Service Bulletin

JAGUAR

Date JANUARY 1984
Sheet 1 of 9
Bulletin JD.01/84

6. Water ingress via seams at "A" post waist – Series III

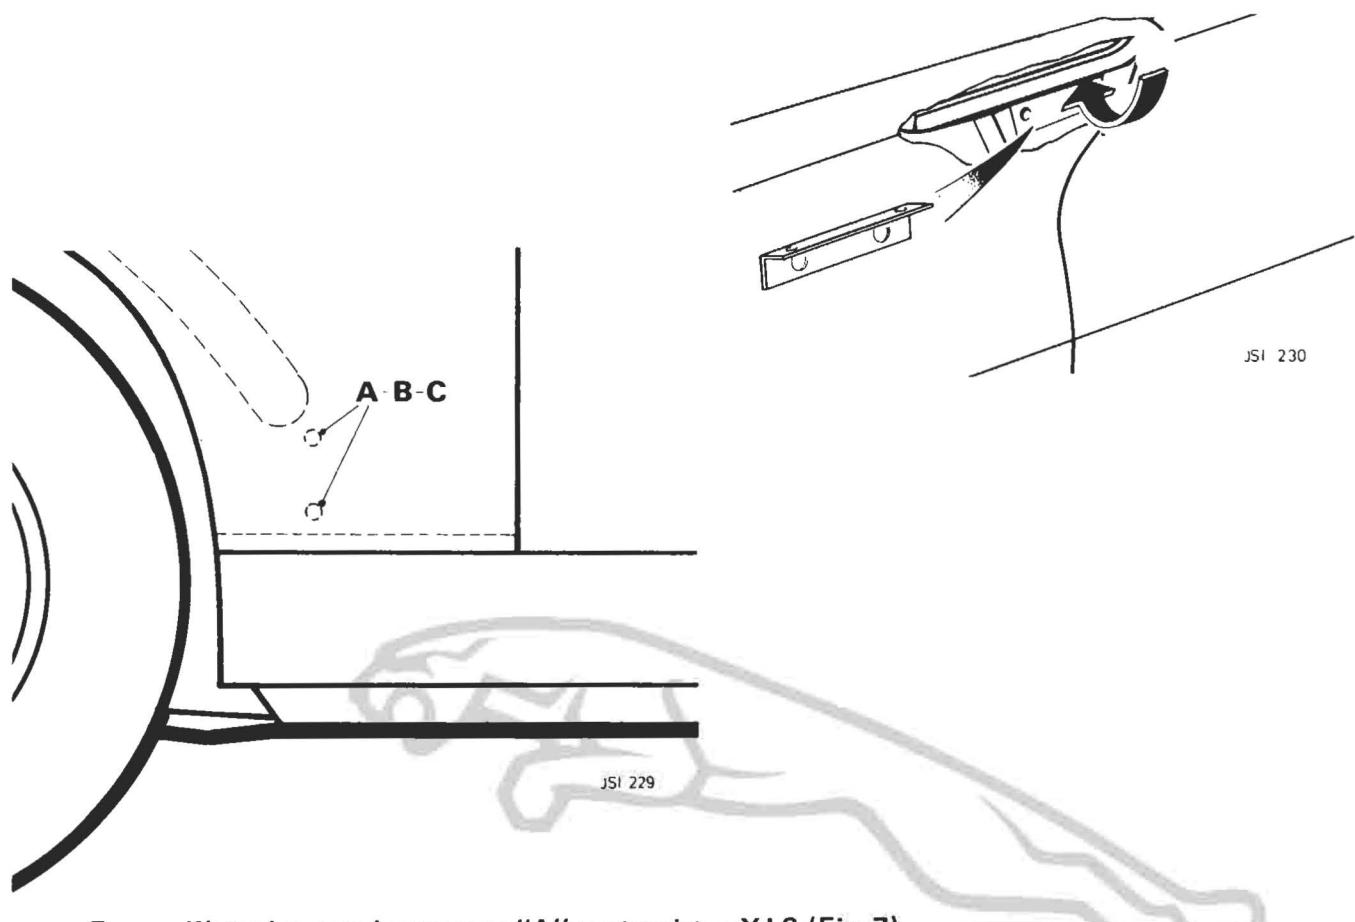
This problem may occur if there is an open seam at the base of the drip rail which allows water to enter the car interior via the "A" post box section.

- A Remove the "A" post draught welt.
- B Remove trim from footwell at base of "A" post (BD 43251 – RH, BD 43252 – LH, BAC 9906 – RH VDP, BAC 9907 – LH VDP).
- C Examine interior of the box section whilst water is "poured" down drip rails.
- D Refer to Fig. 6A and 6B for possible leak areas, and rectify using one of the following methods:
 - i. Leakage from point 6A – remove front wheel arch stone guard and apply sealant "A", "B", or "C".
 - ii. Leakage from point 6B – remove front wing (Workshop Manual Operation 77-28-29) and apply sealant "A", "B", or "C".

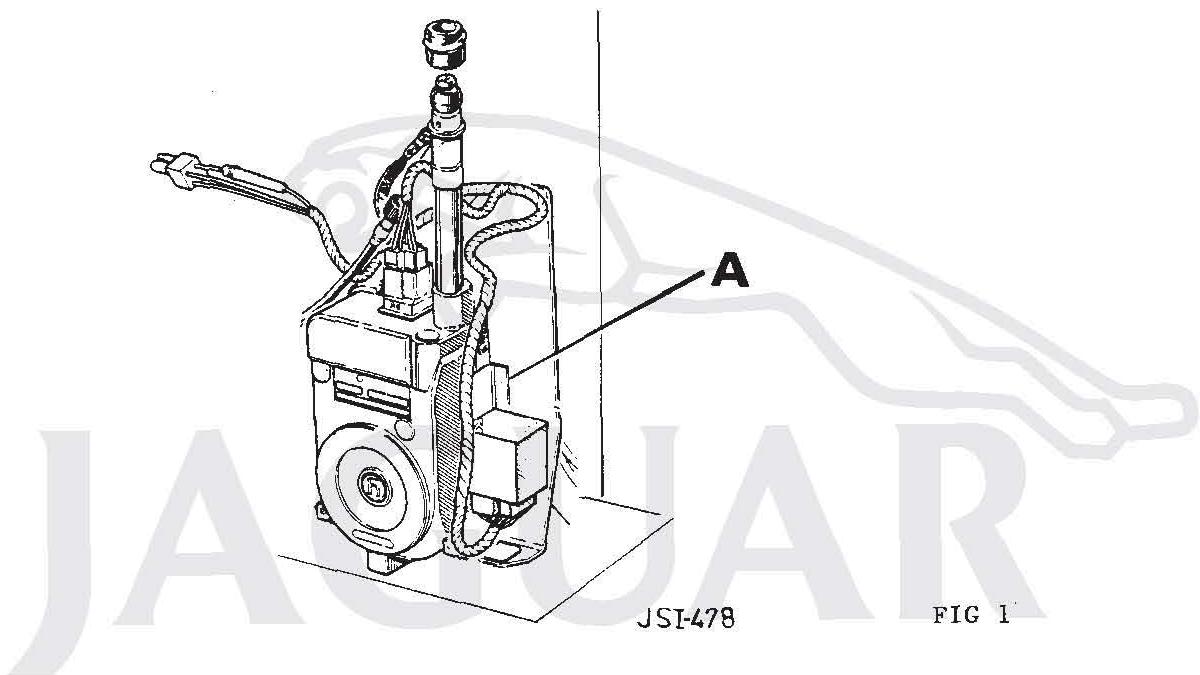
Instances of water entering past the boot lid seal have been experienced on XJS models.

As a result of water entry, vehicles equipped with the Hirschmann Electric Aerial Assembly, from VIN 123281 (JD-07 Item 55 refers), have experienced contamination of the aerial relay, causing aerial operation to be affected.

- a) Disconnect the battery and remove aerial trim panel.
- b) Release the excess relay harness from the clips beneath the inner wing panel.
- c) Remove the relay from the mounting bracket lug, invert and relocate onto lug.
- d) Ensure the harness is routed as Fig. 1 and is clear of the mounting bracket (A).

Fig 10

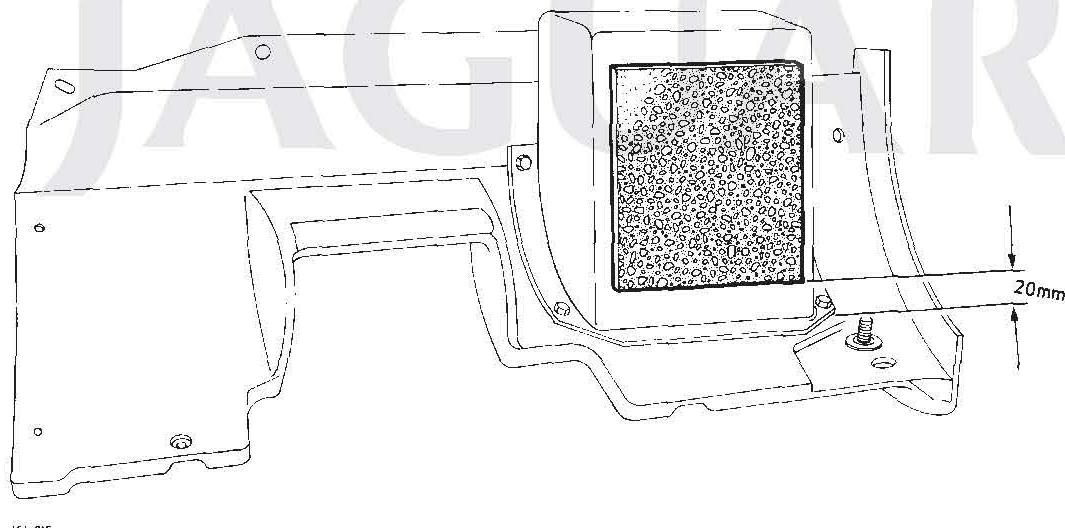
To correct vehicles in service which are affected carry out the following procedure:

- 1 Remove the driverside underscuttle assembly.
- 2 Apply self adhesive anti-rattle foam pad Part No BDC 6348 to the coin box at the position indicated in (Fig 10).
- 3 Replace the underscuttle assembly, and test vehicle for rattles.

Fig 11

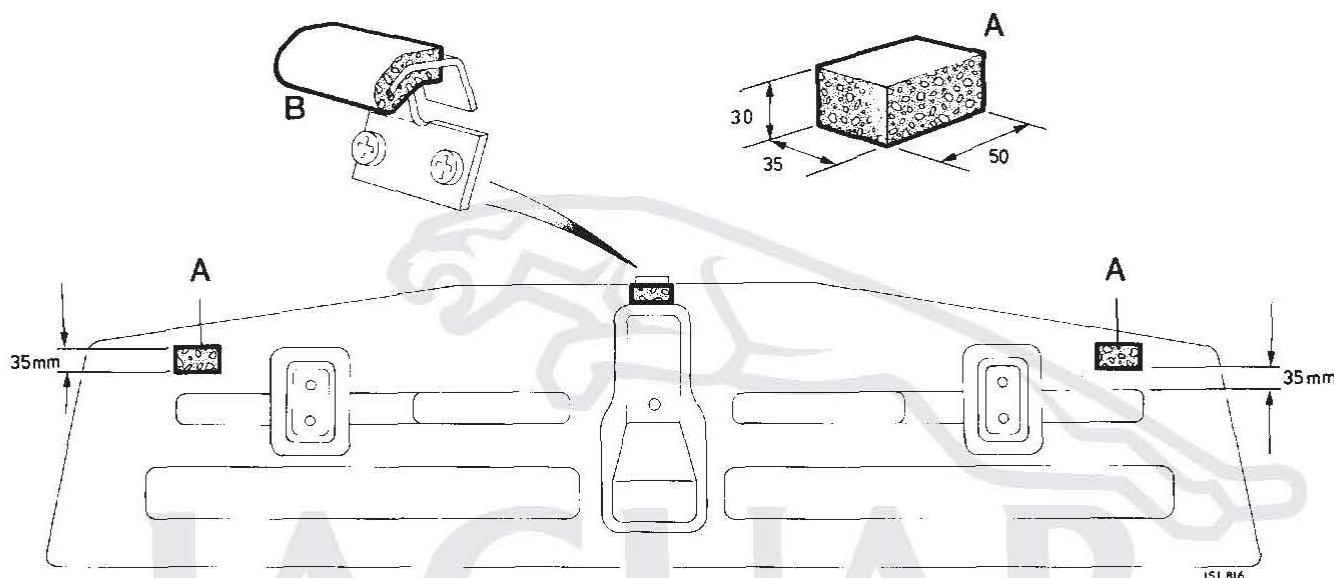
Rattles from the rear parcel shelf trim panel have been eliminated from VIN 527904 when a modification was introduced which incorporates the use of anti-rattle foam pads at three locations. (Fig 11).

- 1 Remove the parcel shelf trim panel to gain access to the panel mounting points and body structure.
- 2 Refer to (Fig 11) to identify the exact locations for the fitment of the self-adhesive anti-rattle foam pads.
- 3 Fit the pads Part No BDC 6468 at the locations (A Fig 11).
- 4 Fit the pad Part No BDC 6469 to the rear trim panel mounting point. (B Fig 11).
- 5 Refit the parcel shelf trim panel and test the vehicle for rattles.

FIG 3

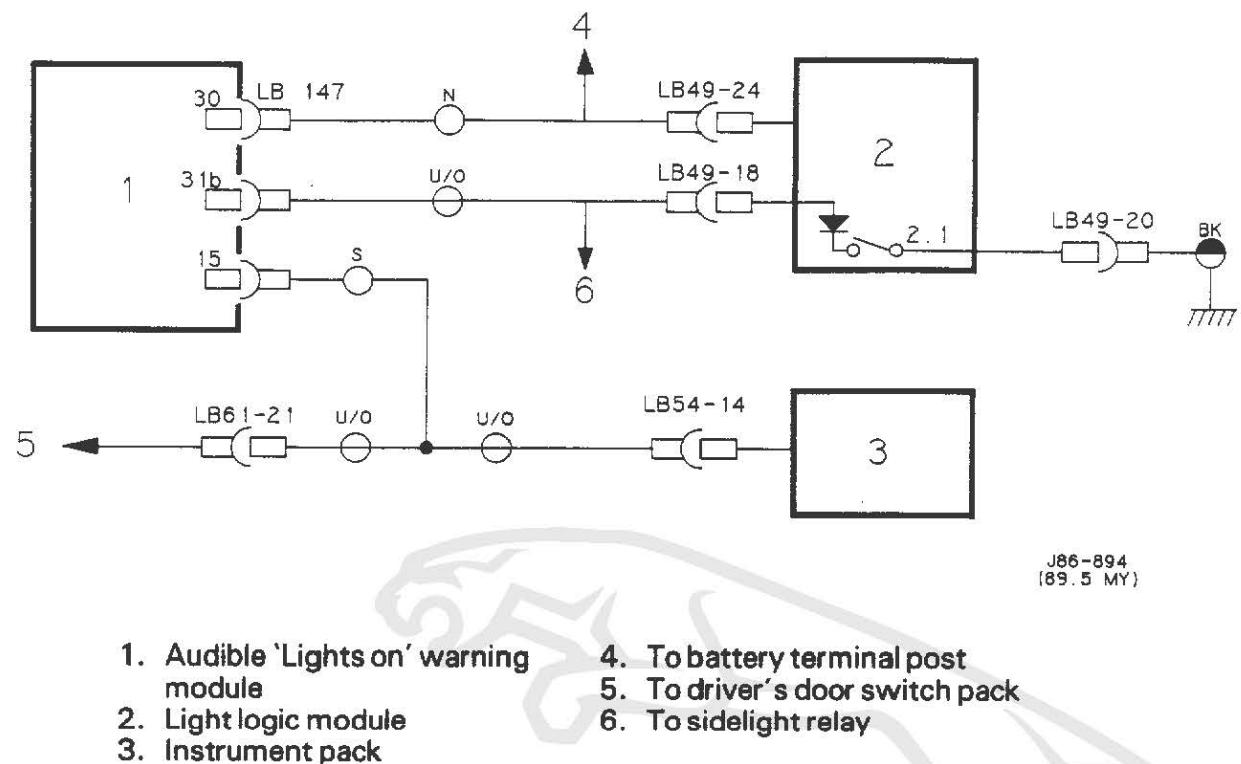
The warning module will produce a continuous tone when the sidelights are on and the driver's door is opened. See Fig 3 below for the schematic diagram.
